MONTICELLO NUCLEAR GENERATING PLANT

Amendment No. 8
License No. DPR-22

ATTACHMENT TO LICENSE AMENDMENT NO. 8
CHANGE NO. 17 TO THE TECHNICAL SPECIFICATIONS
PROVISIONAL OPERATING LICENSE NO. DPR-22
NORTHERN STATES POWER COMPANY
MONTICELLO NUCLEAR GENERATING PLANT
DOCKET NO. 50-263

TORUS-TO-DRYWELL VACUUM BREAKER LEAKAGE

FIGURE 3.7.1

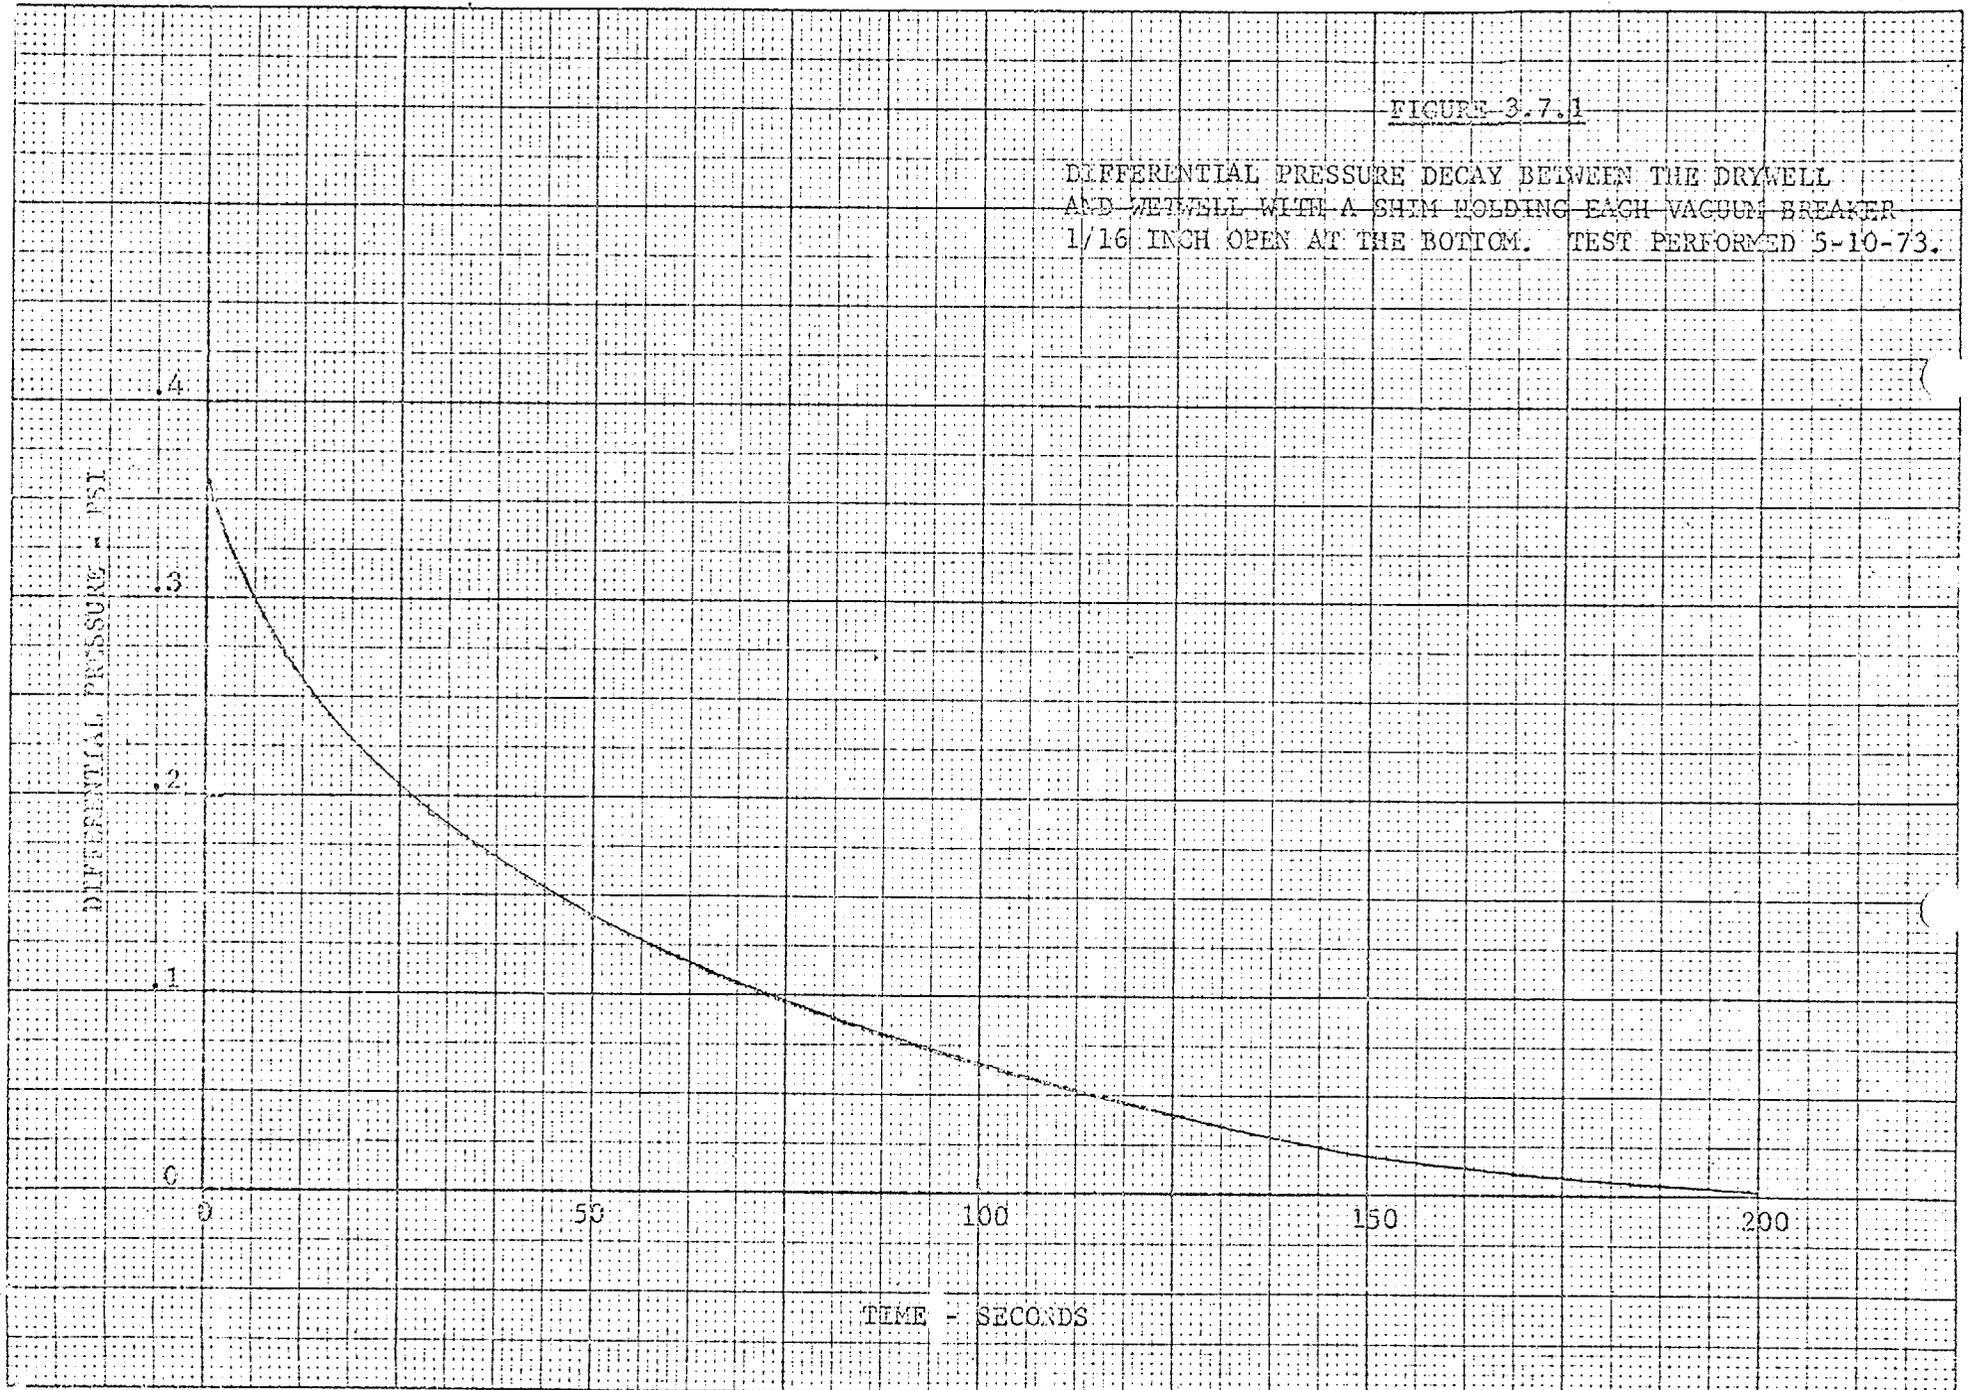
- b. When the position of any drywell-suppression chamber vacuum breaker valve is indicated to be not fully closed at a time when such closure is required, the drywell to suppression chamber differential pressure decay shall be demonstrated to be less than that shown on Figure 3.7.1 immediately and following any evidence of subsequent operation of the inoperable valve until the inoperable valve is restored to a normal condition.
- c. When both position alarm circuits are made or found to be inoperable, the control panel indicator light status shall be recorded daily to detect changes in the vacuum breaker position.

During reactor operation, an exercise test of the vacuum breakers will be conducted monthly. This test will verify that disc travel is unobstructed and will provide verification that the valves are closing fully through the position indication system. If one or more of the vacuum breakers do not seat fully as determined from the indicating system, a leak test will be conducted to verify that leakage is within the maximum allowable. Since the extreme lower limit of switch detection capability is approximately 1/16", the planned test is designed to strike a balance between the detection switch capability to verify closure and the maximum allowable leak rate. A special test was performed to establish the basis for this limiting condition. During the first refueling outage all ten vacuum breakers were shimmed 1/16" open at the bottom of the disc. The bypass area associated with the shimming corresponded to 63% of the maximum allowable.¹ The results of this test are shown in Figure 3.7.1.
